Subject: Response to U.S. Environmental Protection Agency Comments, dated July 25, 2017, on the 2016  
*Annual Remedy Performance Report*  
2040 West River Drive, Davenport, Iowa  
Harcros Chemicals EPA ID No. IAD022100671  
Docket No. RCRA-07-2012-0013

### EPA Comments on the Draft 2016 Annual Remedy Performance Report (ARPR), Harcros Chemicals, 2040 West River Drive, Davenport, Iowa, EPA ID No. IAD022100671

**August 25, 2017 Replacement Pages for Draft 2016 *Annual Remedy Performance Report* (ARPR),  
Harcros Chemicals, 2040 West River Drive, Davenport, Iowa, EPA ID No. IAD022100671**

Figure 3-1  
Unconsolidated Zone  
June 2016 Potentiometric Surface  
2040 West River Drive  
Davenport, Iowa

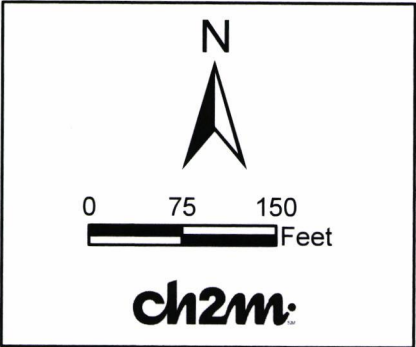
3. **Figure 3-2, *Unconsolidated Zone June 2016 Potentiometric Surface*:** Groundwater elevation was measured at 565.54 feet amsl at monitoring well (MW)-03, not 567.48 feet amsl, which is a duplicate of the water level measured at MW-04. The figure should be corrected.

**Respondents' Response:** Because EPA is referring to an unconsolidated zone well, the correct figure reference is for Figure 3-1, not Figure 3-2. Figure 3-1 has been updated to revise the groundwater elevation at monitoring well MW-03 to 565.54 feet amsl. The updated figure is included in Attachment B, and serves as the replacement figure for the 2016 ARPR, dated February 24, 2017.

Table G-1. CVOC Daughter Products Trend Data Summary for Wells with June 2016 "Increasing" Mann-Kendall Trend Analysis Results  
THAN Davenport Site, 2040 West River Drive

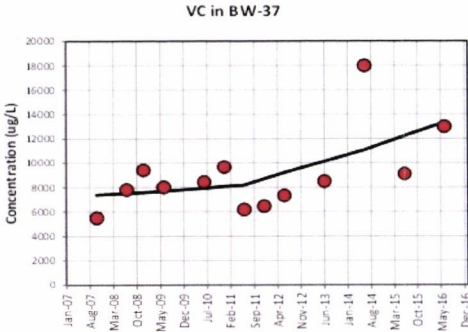
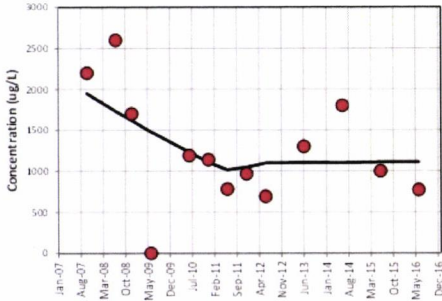
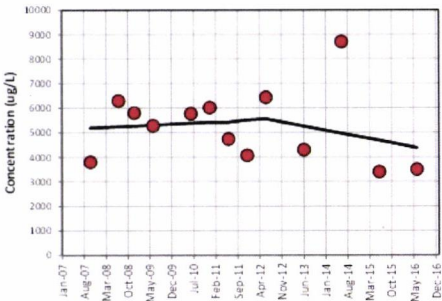
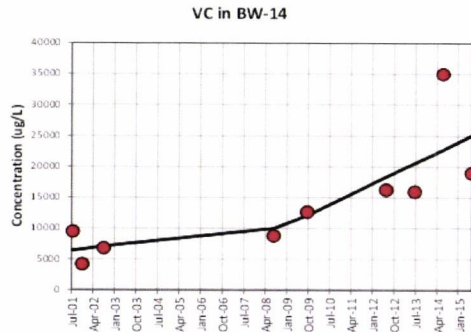
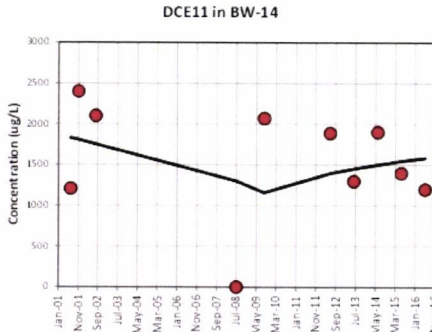
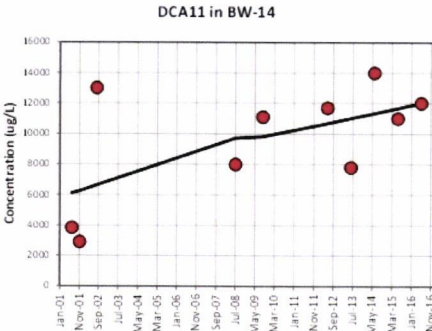
- a. **BW-27:** Appendix G states that locally weighted scatter plot smoothing curves indicate concentrations are *increasing* for additional CVOC daughter compounds 1,1-DCE and 1,1-DCA at BW-27. The report should include a depiction of these scatter plots within Appendix F and G to provide a basis for conclusions made in Appendix G.

- b. **BW-37:** Appendix G indicates that locally weighted scatter plot smoothing curves indicate concentrations are *decreasing* for additional CVOC daughter compounds 1,1-DCE and 1,1-DCA at BW-37. The report should include a depiction of these scatter plots within Appendix F and G to provide a basis for conclusions made in Appendix G.

- c. **BW-14:** It is stated within Appendix G that locally weighted scatter plot smoothing curves indicate concentrations are *stable* for additional CVOC daughter compounds 1,1-DCE and 1,1-DCA at BW-14. The report should include a depiction of these scatter plots within Appendix F and G to provide a basis for conclusions made in Appendix G.

**Respondents' Response:** Table G-1 of Appendix G has been updated to include the six requested graphs. Three replacement pages containing the revised Table G-1 are included Attachment B of this document, and serve as the replacement table to the 2016 ARPR, dated February 24, 2017.

PROJECT NUMBER <b>158742.DV.FI</b>	WELL NUMBER <b>BW-06</b>	SHEET 1 OF 1
<b>WELL COMPLETION DIAGRAM</b>

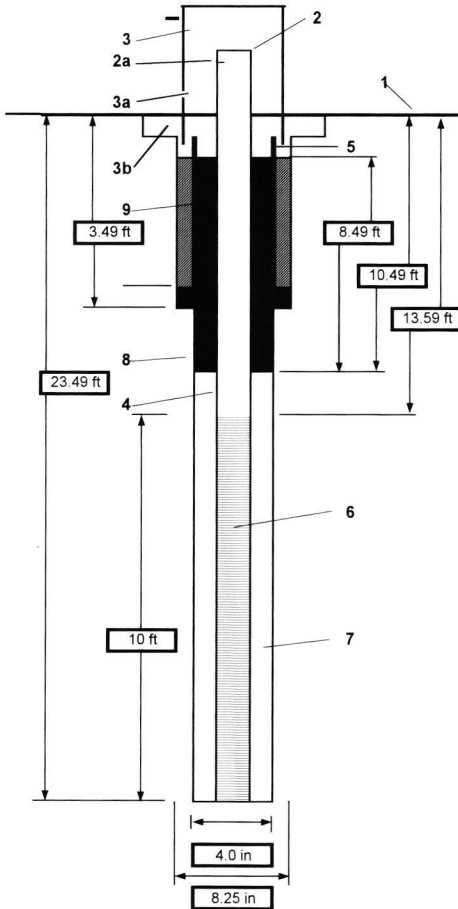
It is noted that in Table 2-1 of the report that the top of casing elevation and ground elevation listed for bedrock well (BW)-06 appears to be transposed since the table indicates that the ground elevation is at 567.01 feet amsl and the top of casing is at 563.97 feet amsl. This would indicate that the top of casing is approximately three feet below ground surface, which is inconsistent with all other well construction completions at the Facility. The above table assumes that the two elevations are transposed and the calculations were corrected accordingly. Table 2-1 should be revised accordingly.

**BW-06:** As discussed in the 2015 ARPR, a new loading dock was constructed in the vicinity of BW-06 since its installation, and as a result of the construction the well's surface completion was converted from a stick-up type to a flush-mount type in 2006. The top of casing elevation and ground surface elevation at this well changed as a result of the construction and was resurveyed in 2015. The top of casing elevation provided in Table 2-1 was updated to match this survey; however, the ground surface elevation, depth to bedrock, and depth to the bottom of the screened intervals were inadvertently not revised. Based on the construction information presented in the revised Table 2-1 (provided in Attachment B), this well is occluded by less than 5 percent and will not be redeveloped at this time.

PROJECT NUMBER <b>158742.DV.FI</b>	WELL NUMBER <b>MW-17</b>
SHEET 1 OF 1	
<b>WELL COMPLETION DIAGRAM</b>

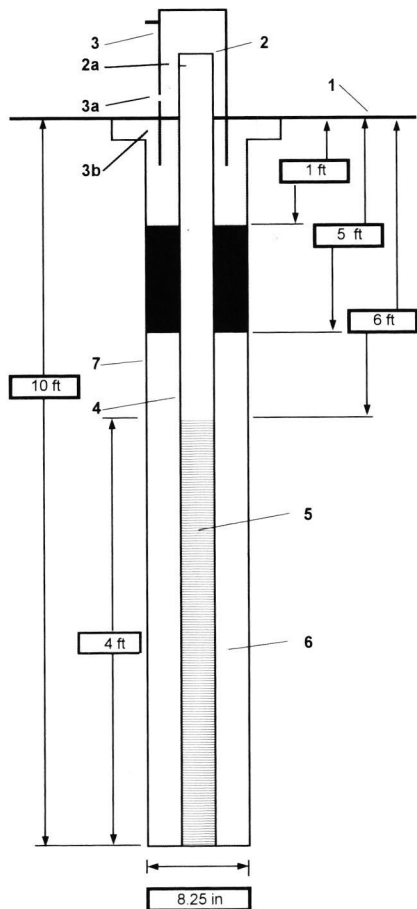
As previously commented, the report should provide recommendations for re-development of these wells or other corrective measures to re-store the hydraulic connection between the well screens and the aquifer. Additionally, future reports should include the measured total depth of the wells within the well construction and groundwater elevations table for comparisons.

**MW-17:** The historical field forms documenting the installation of MW-17 were reviewed, and the construction information included in Table 2-1 of the 2016 ARPR is erroneous. The bottom of the well screen at MW-17 is 10 feet below ground surface, which corresponds to an elevation of 551.73 feet above mean sea level [amsl]). Using this updated information, the percent occlusion is 7.9. As noted in Table 2-1 above, monitoring well MW-17 is not part of the long-term monitoring program outlined in the EPA-approved *Operation, Monitoring, and Maintenance Plan* (OMMP). Groundwater level measurements are collected from this well to supplement the potentiometric surface map in the unconsolidated bedrock zone. Because this well is not used for sampling, there is not a need to redevelop it.
